Re-submittal Form

Development Review Team Comments

Project Name: Sherrelwood Village Filing No. 2

Commenting Division: Planning Review **Name of Reviewer**: Alan Sielaff, Planner II **Email**: ASielaff@adcogov.org / 720-523-6817 **Review Status**: **Resubmittal Required**

Sheet 5

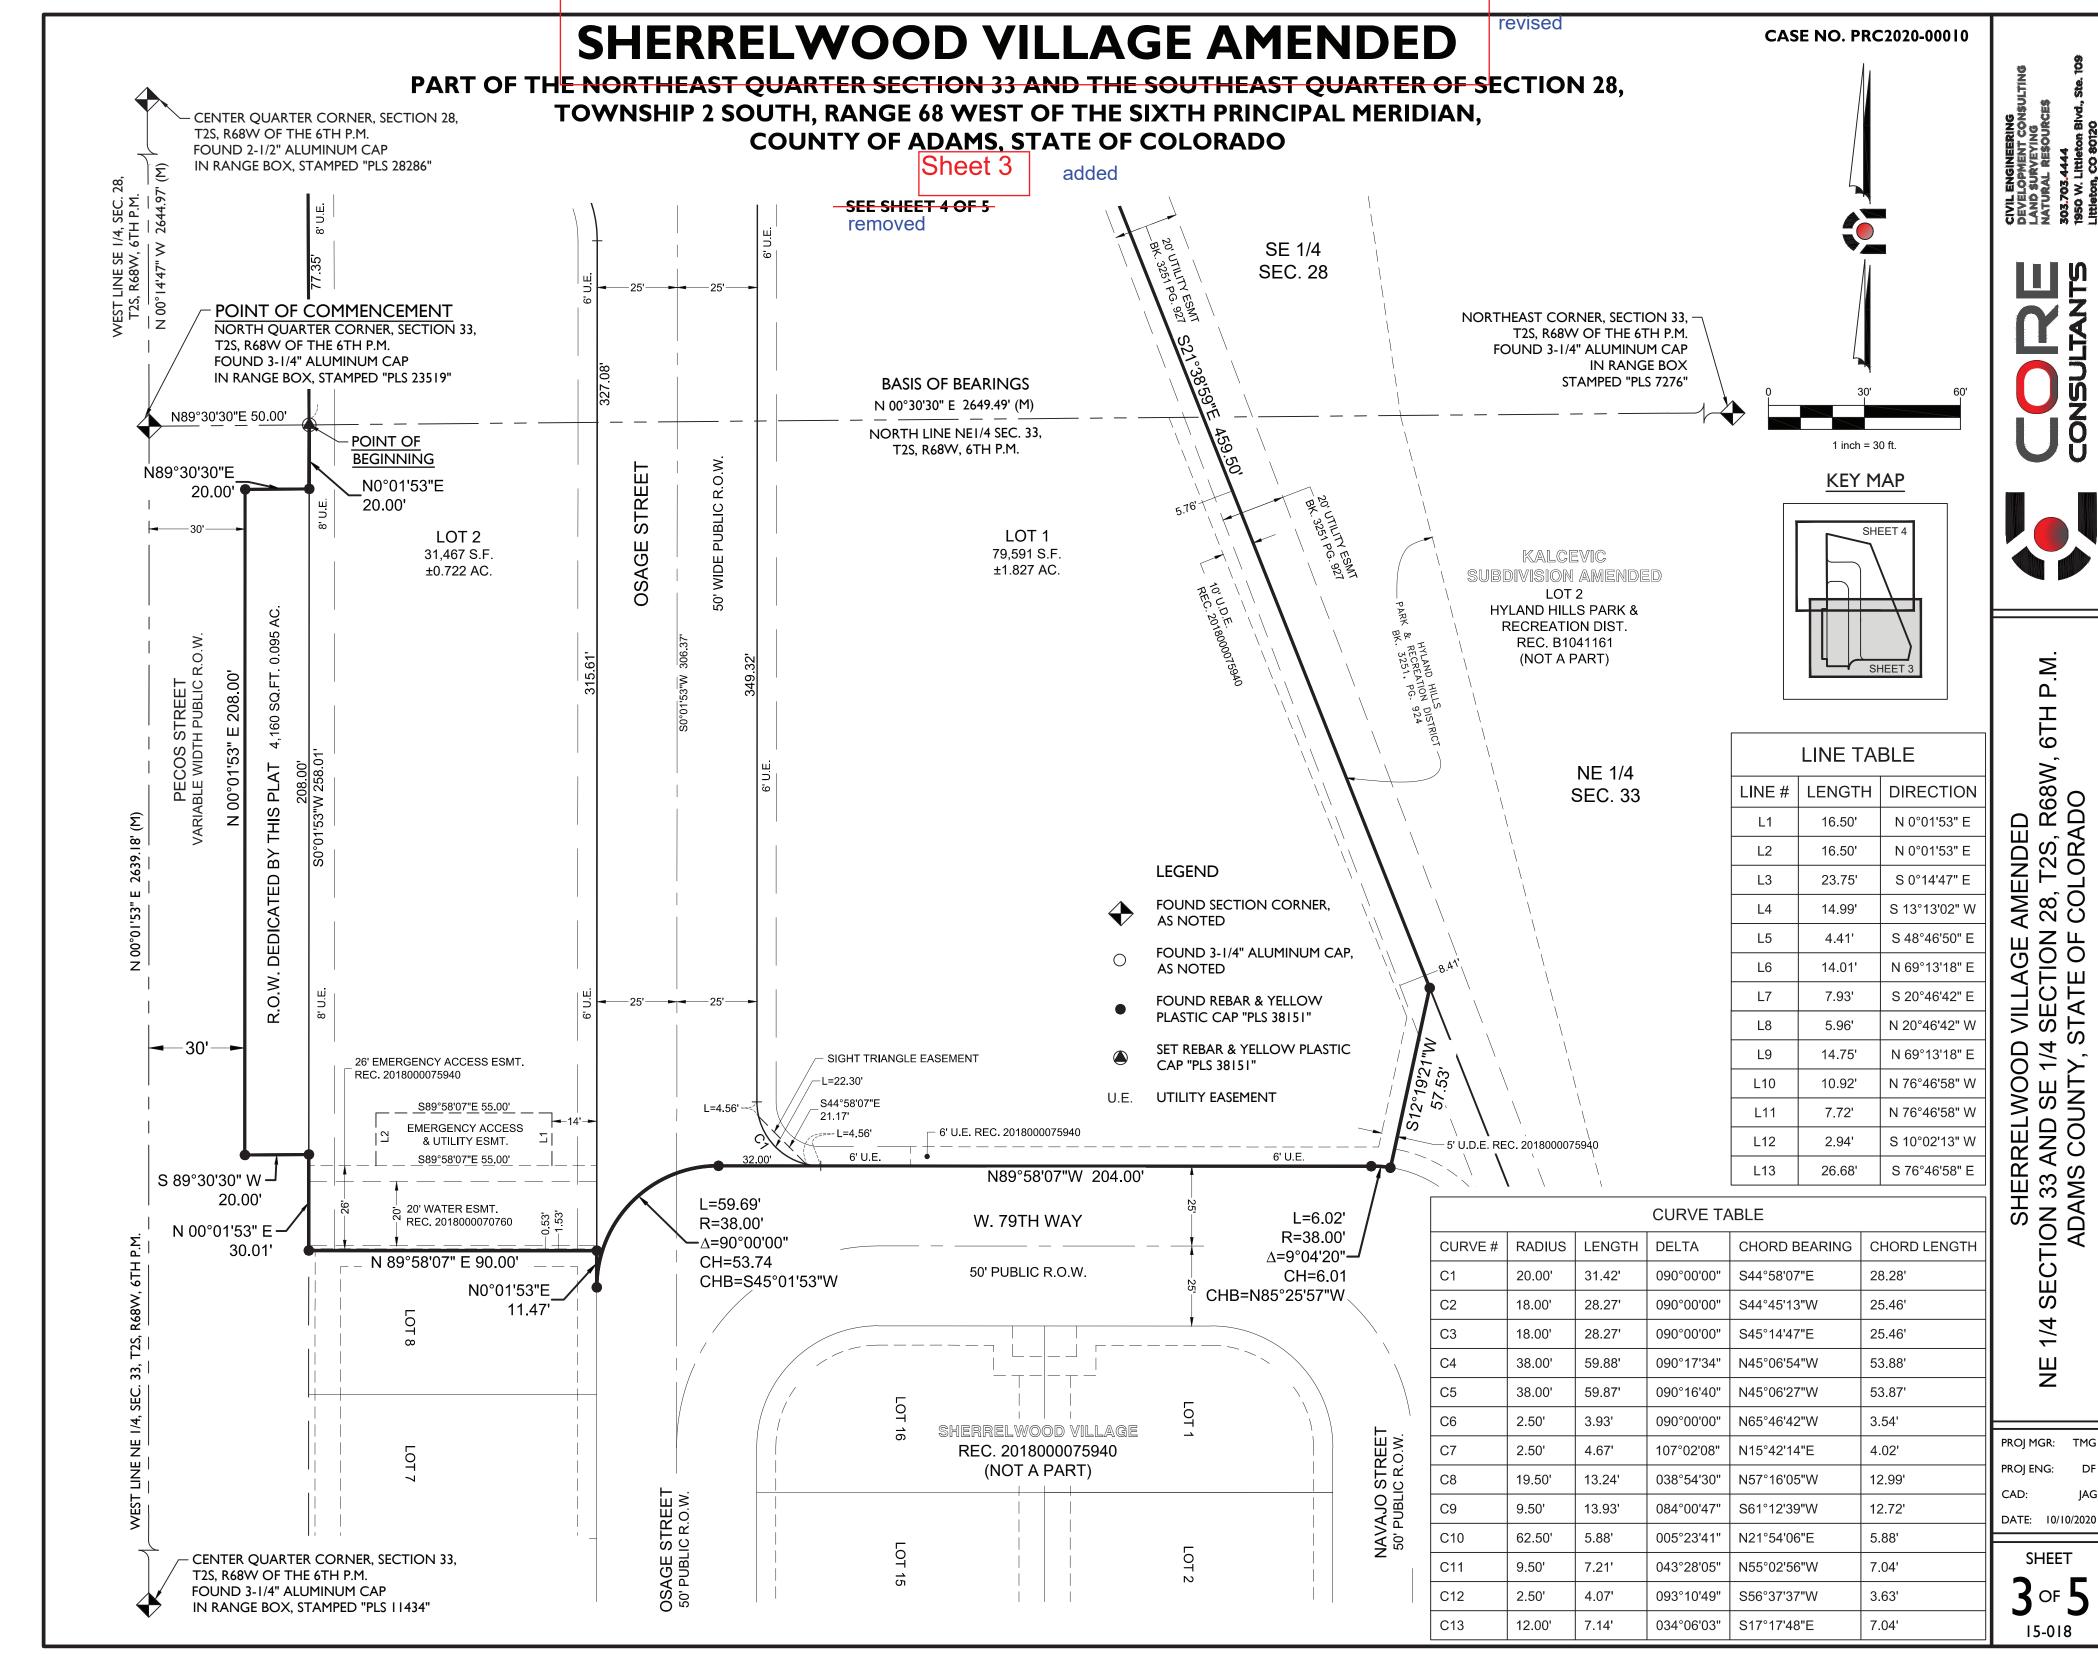
Add Access Provisions note that is listed as item #6 on the Preliminary Plat Subdivision Checklist Requirements" document.

access note added per Subdivision Checklist

SHEET 3 OF 3

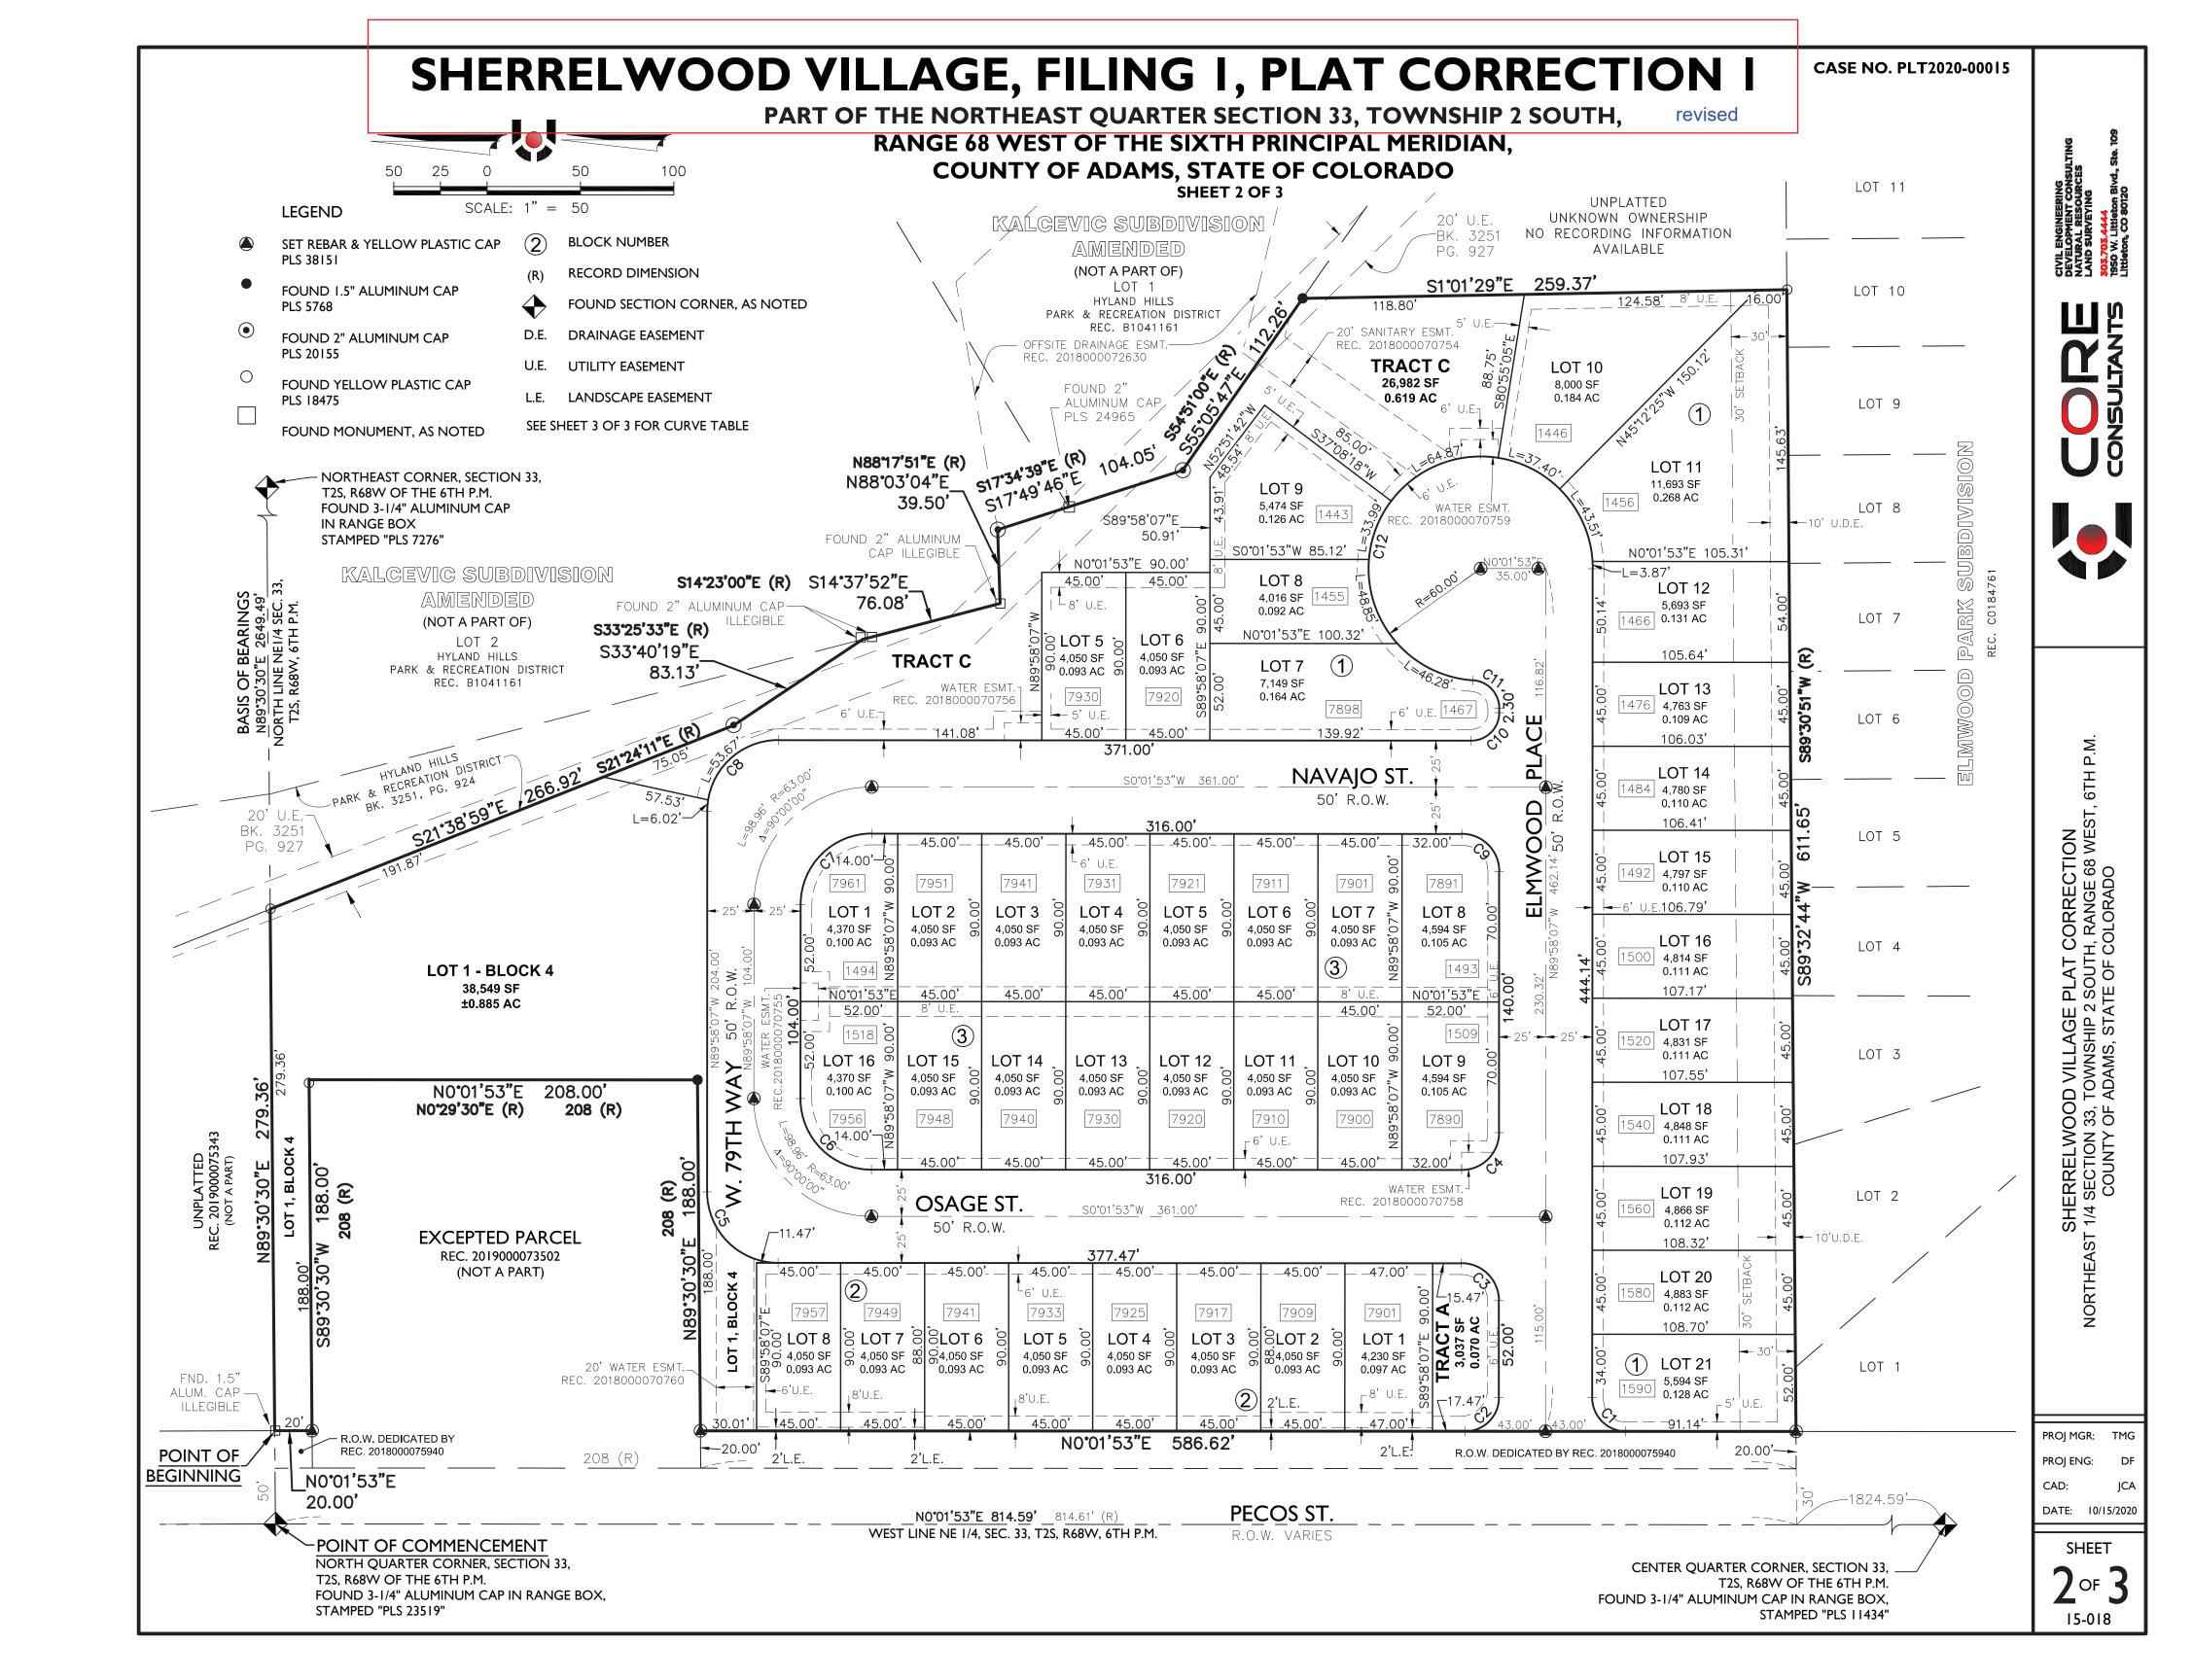
Revise to provide updated Title information.

Add
Statement
Restricting
Access and
Storm
Drainage
Facilities
Statement
as Plat
notes.

requested notes added.
